Addendum #2 for
St. Joseph University Catholic Parish
Terre Haute, IN
Parish Hall
September 17, 2026

CHANGES TO THE PROJECT MANUAL

CHANGES TO THE DRAWINGS

C200

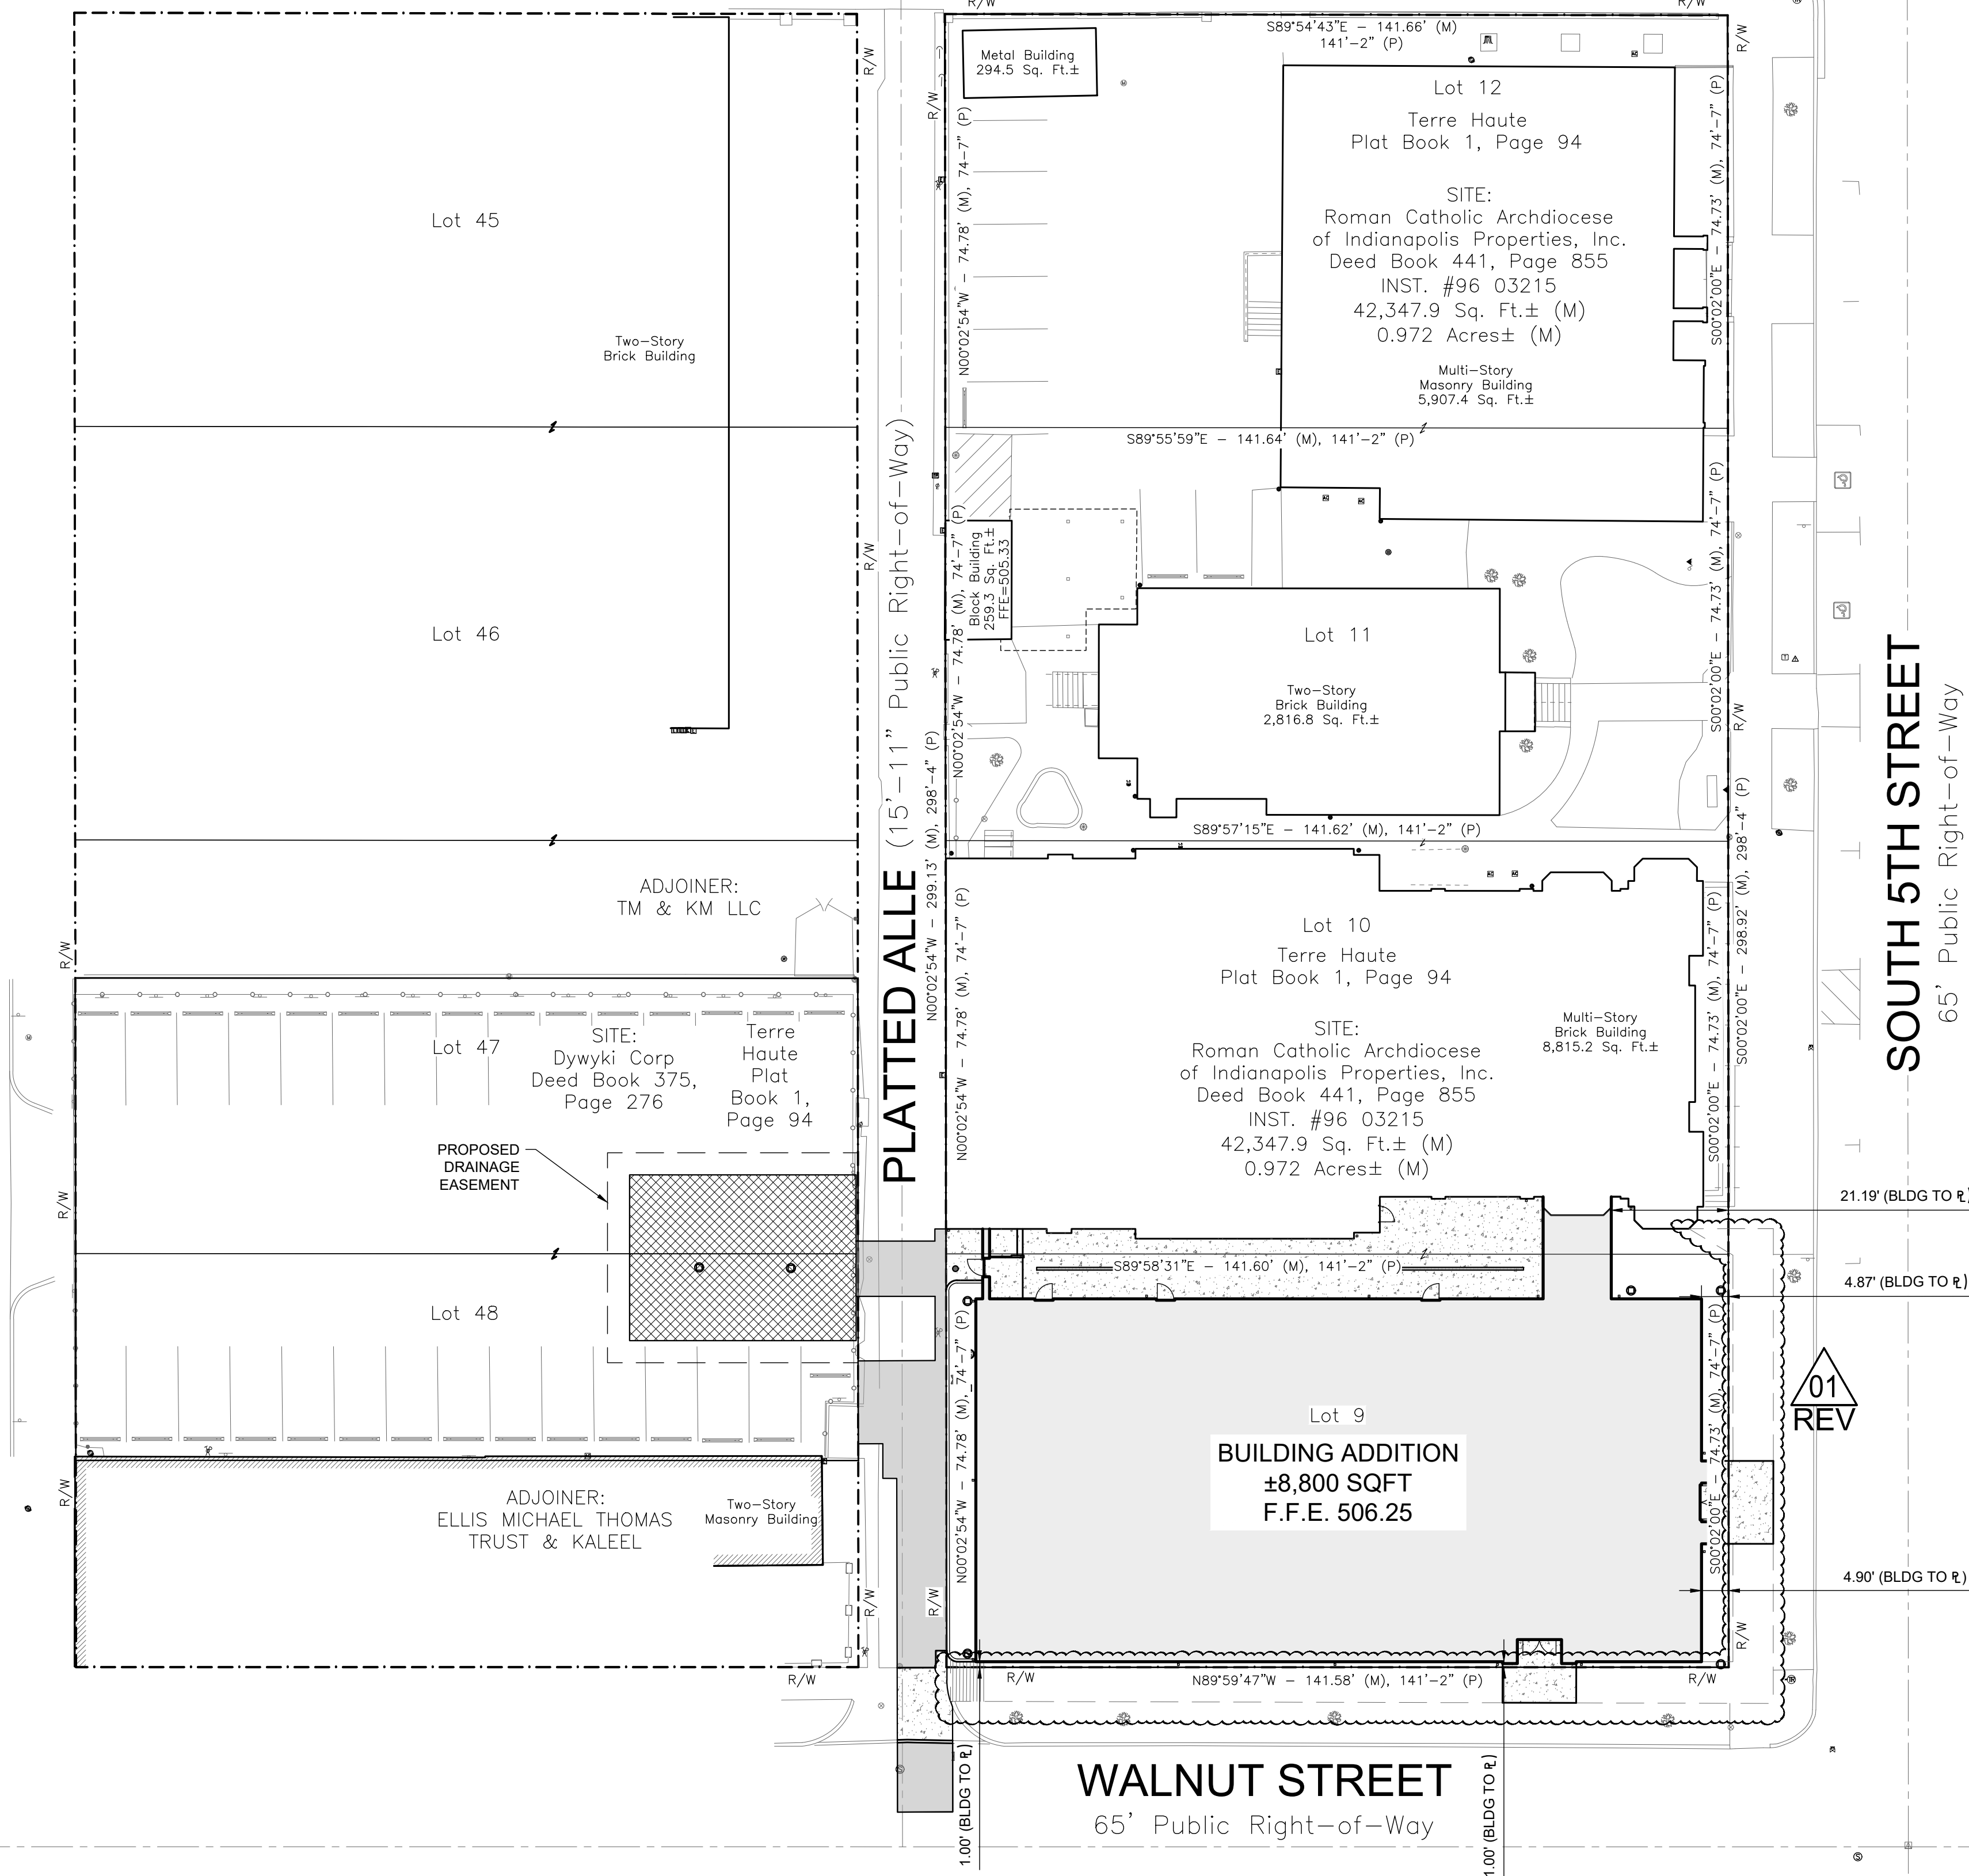
1. Proposed sidewalk along Walnut and South 5th Street has been removed except for pads at building access points. Replace sheet in its entirety.

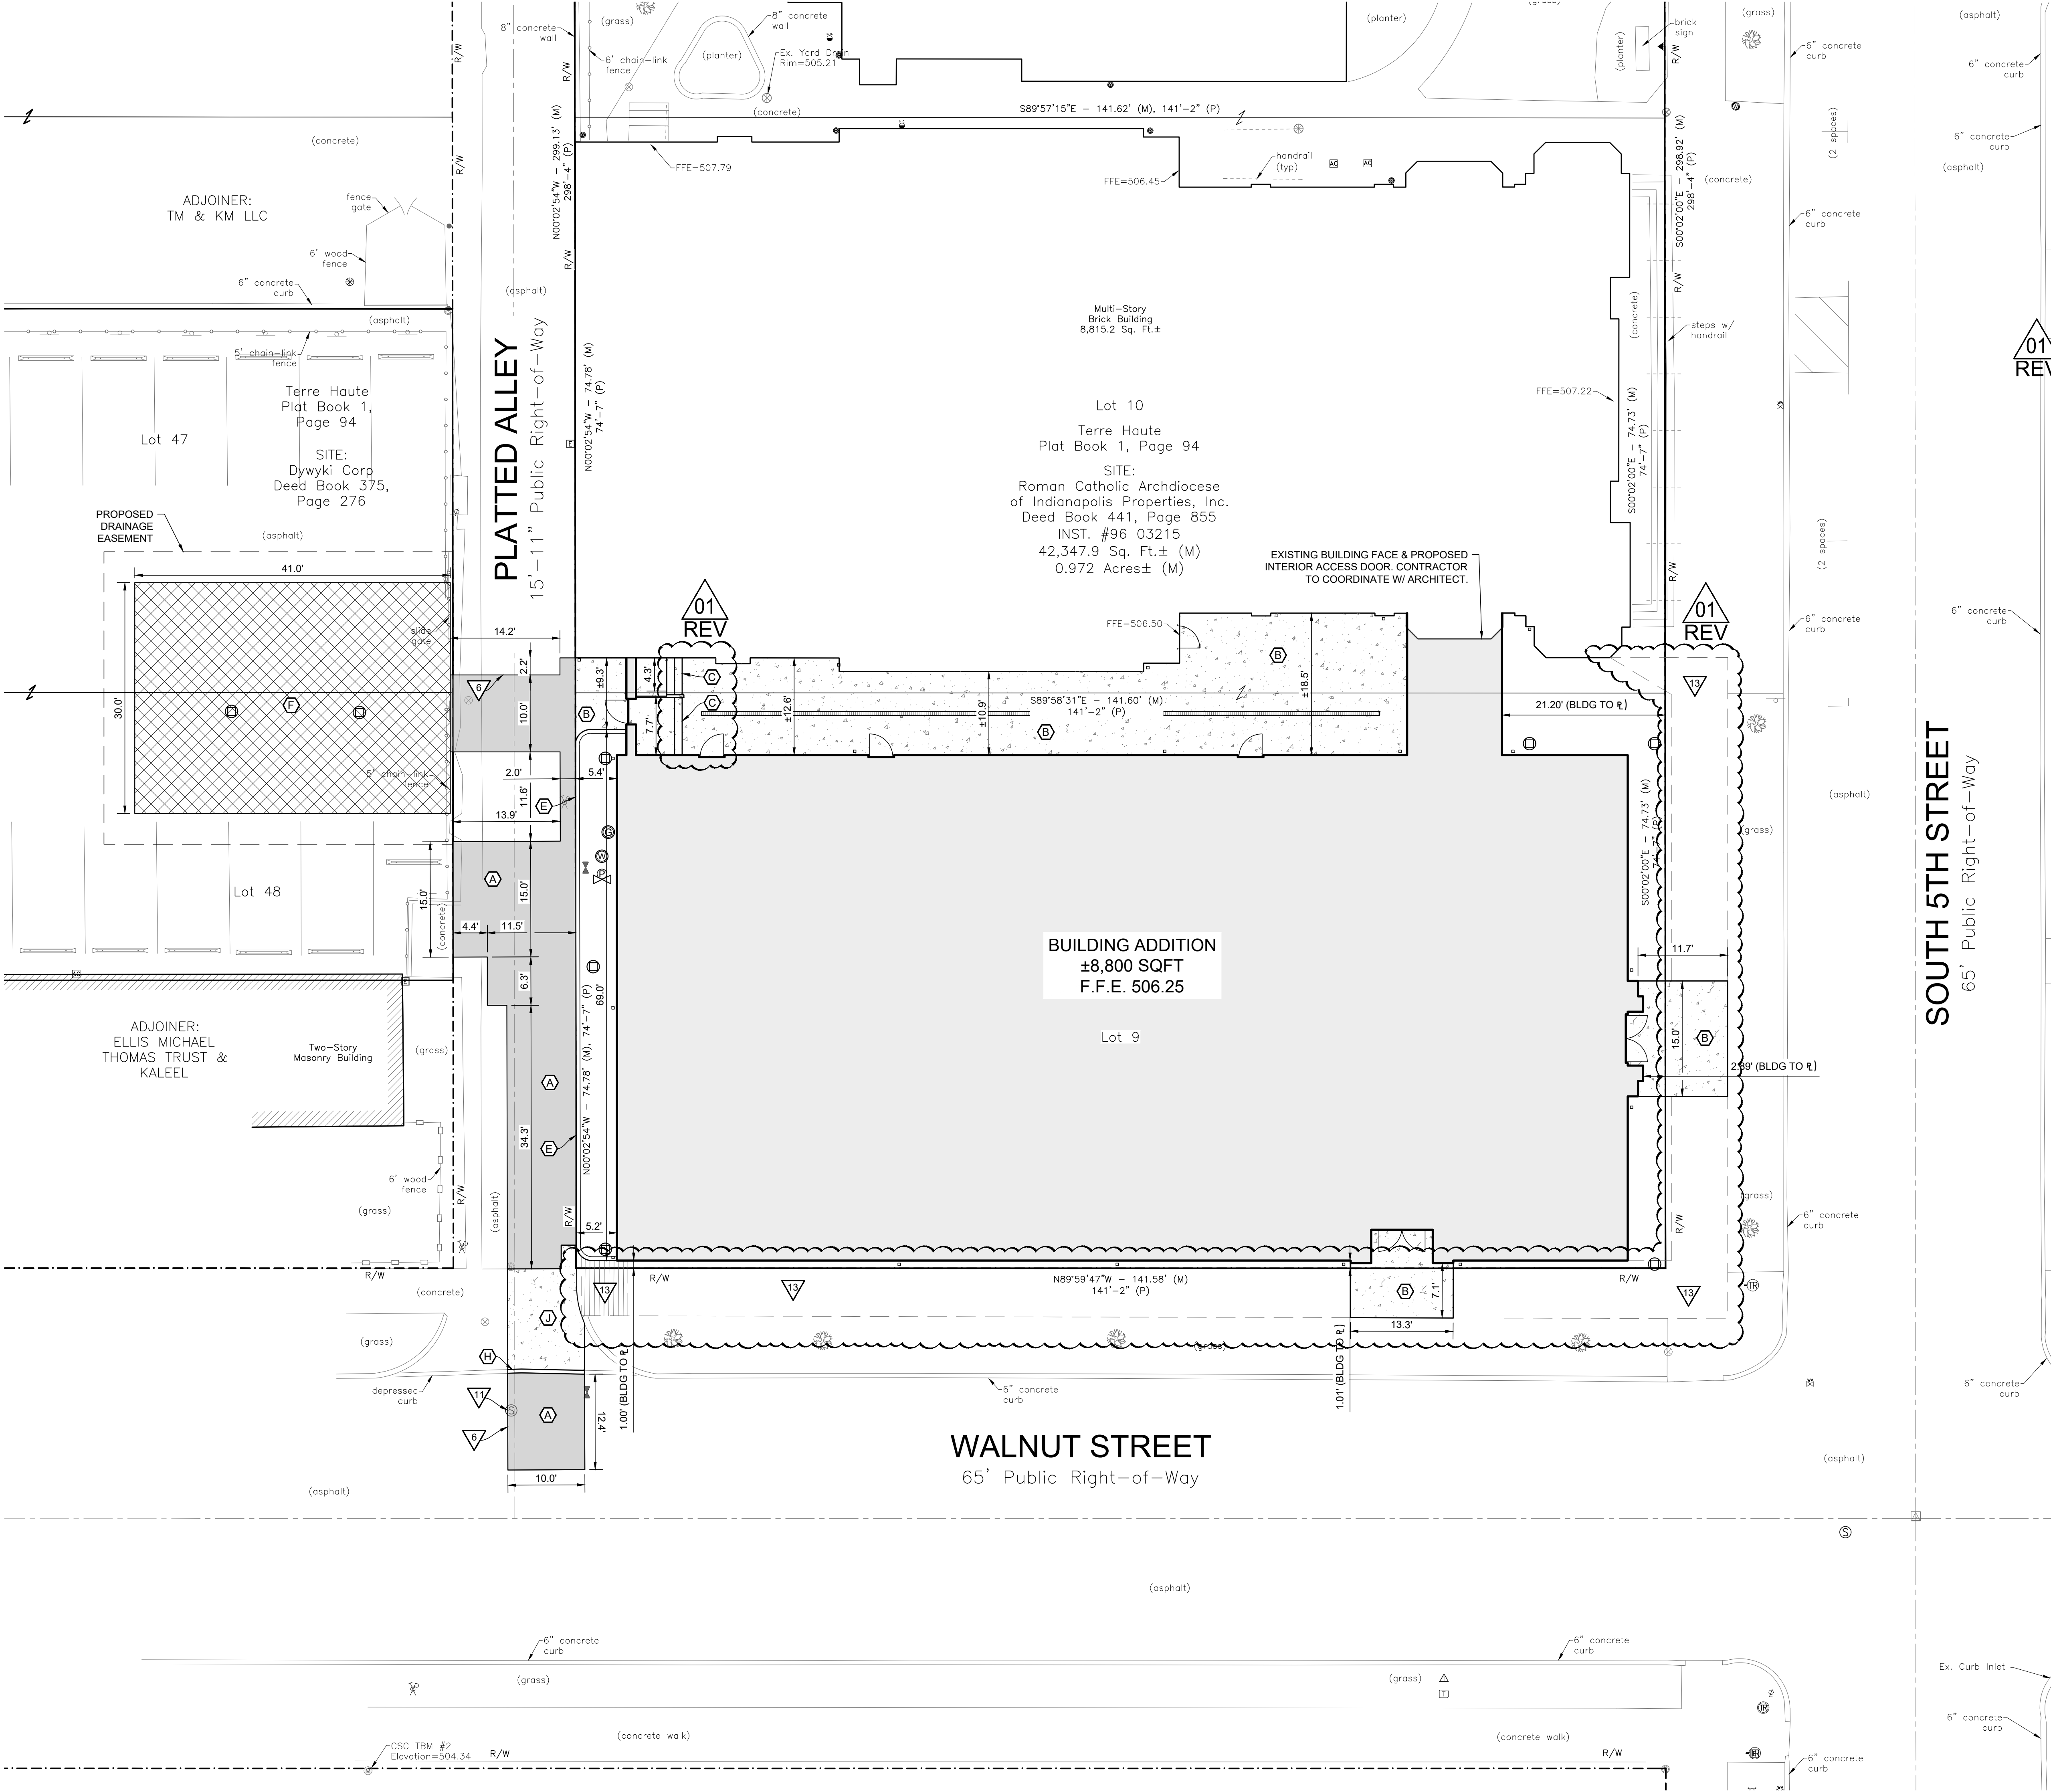
1. Callout 'H' added to trees along Walnut and South 5th Street for removal. Replace sheet in its entirety.

SITE PLAN
C210

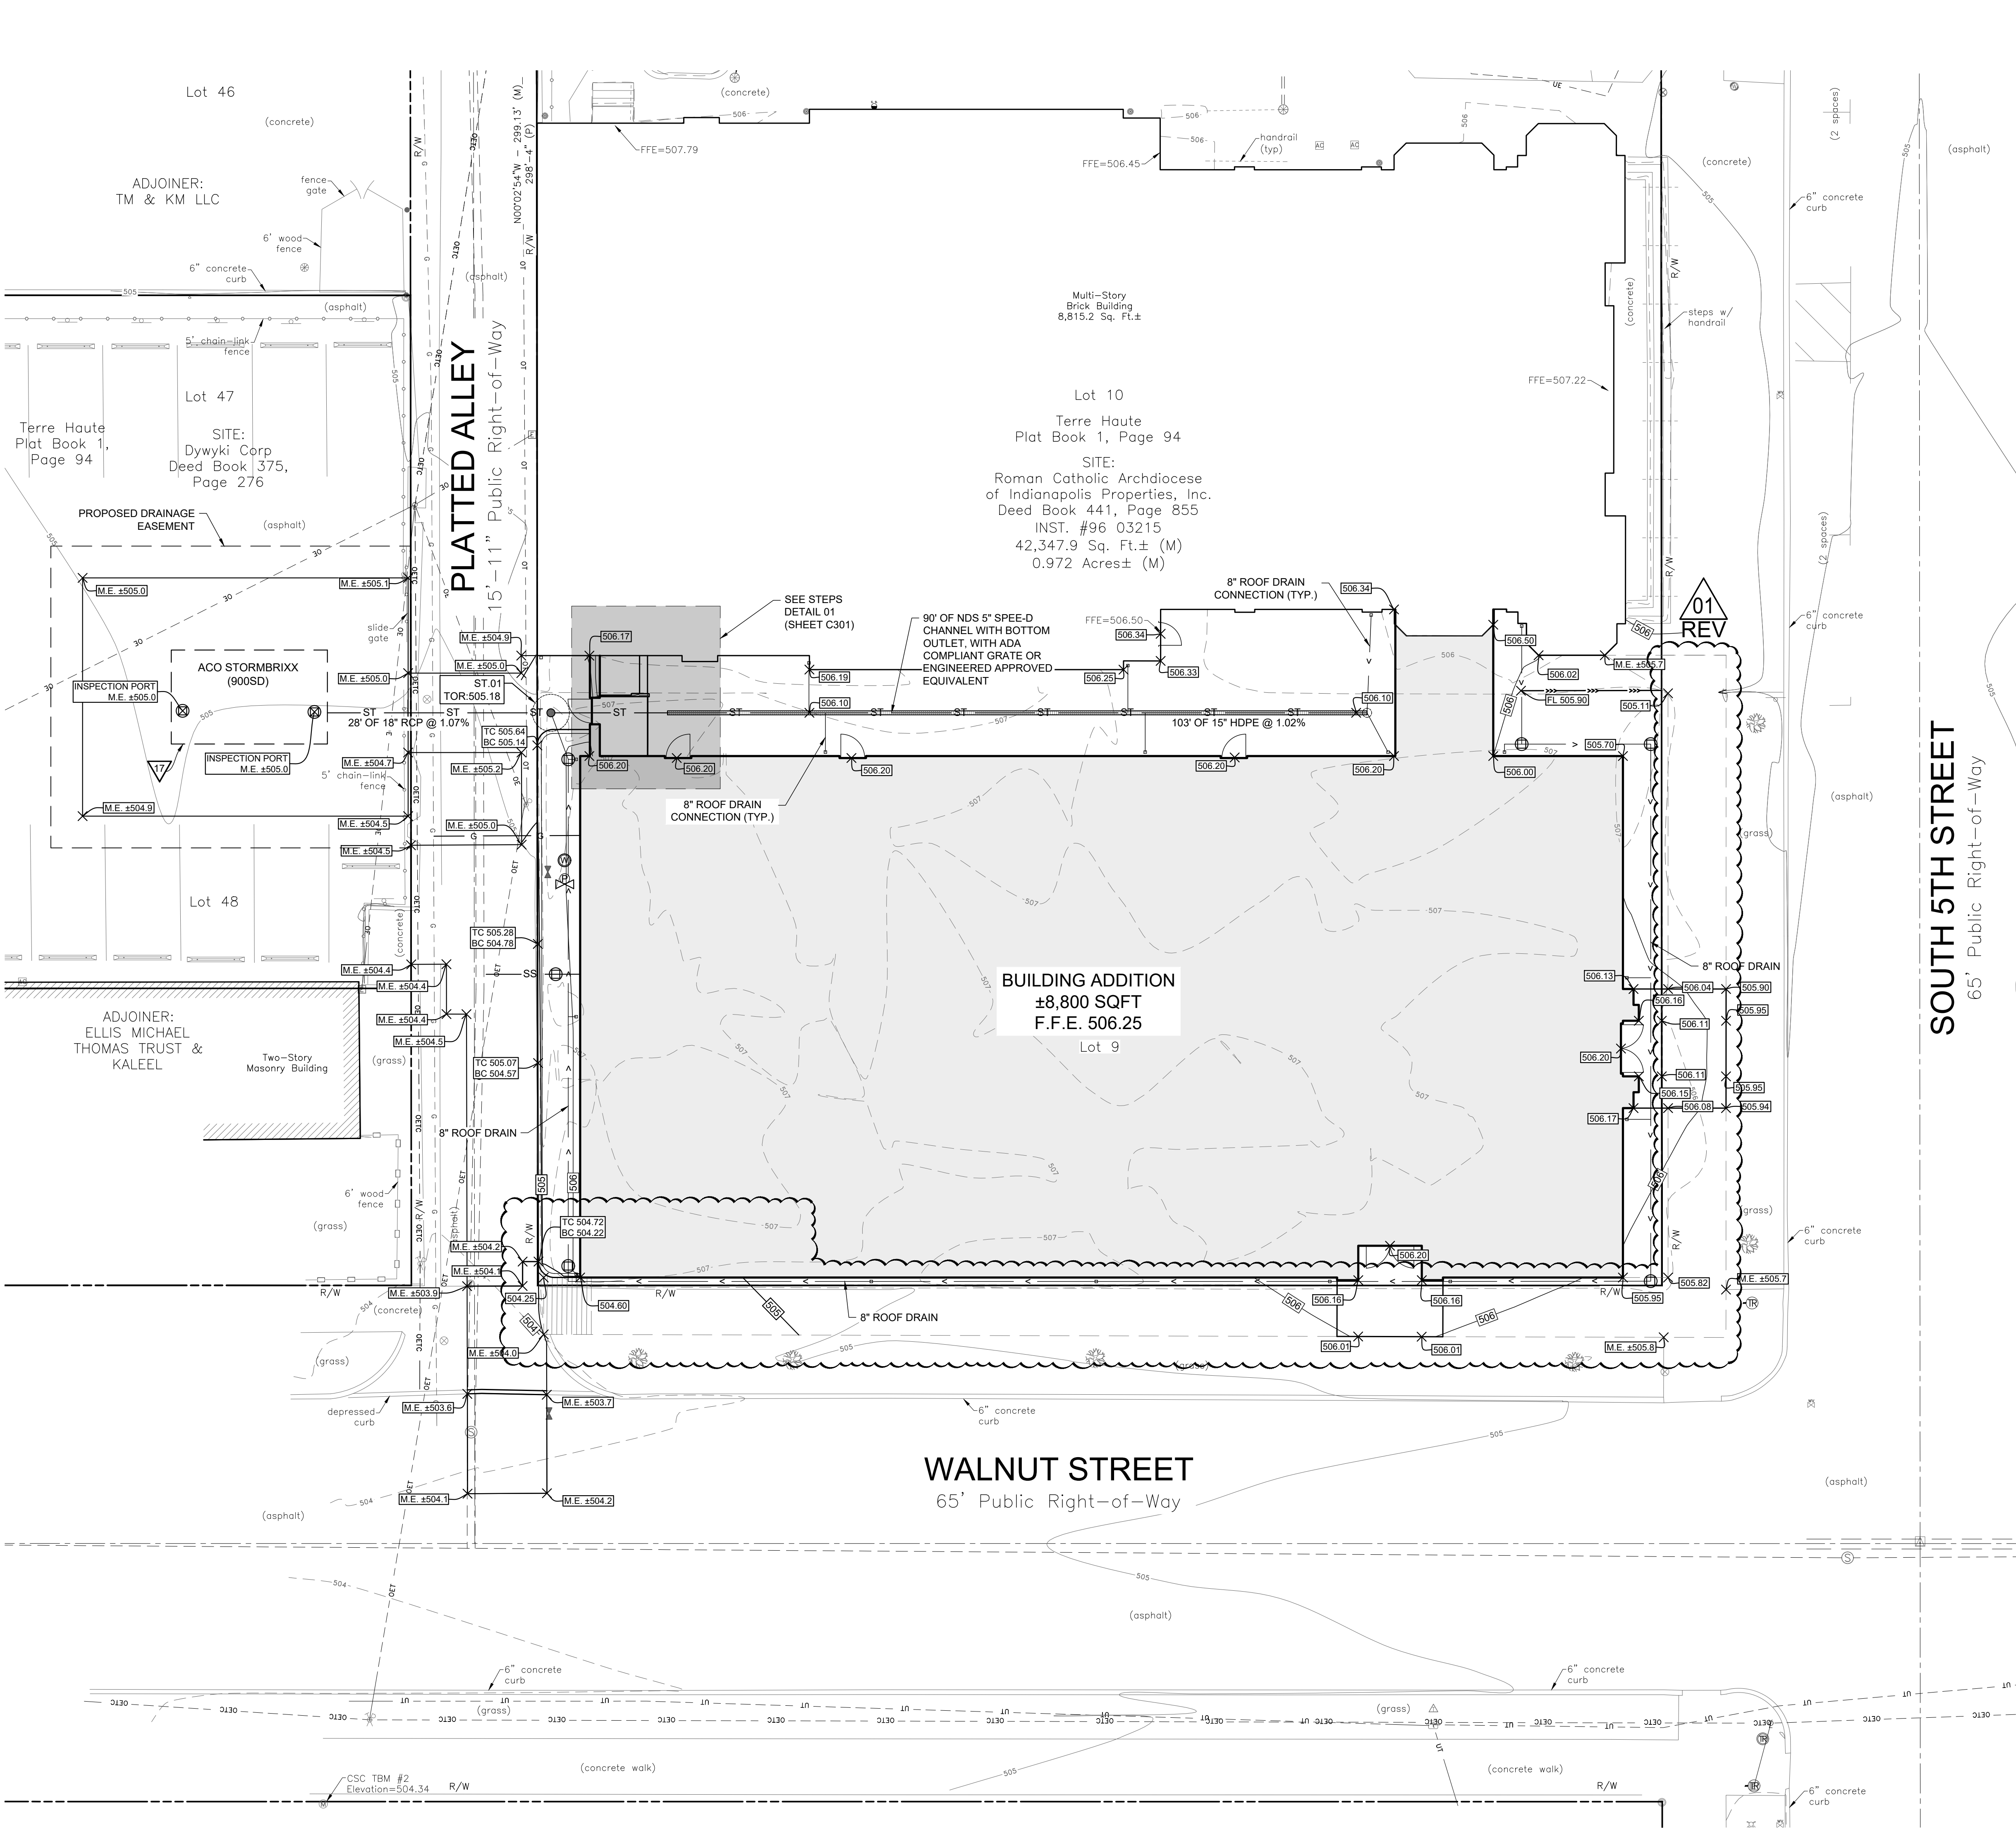
1. Proposed sidewalk along Walnut and South 5th Street has been removed except for pads at building access points.
2. Note 13 added for information on right of way sidewalk / ramp construction by others.
3. Replace sheet in its entirety.
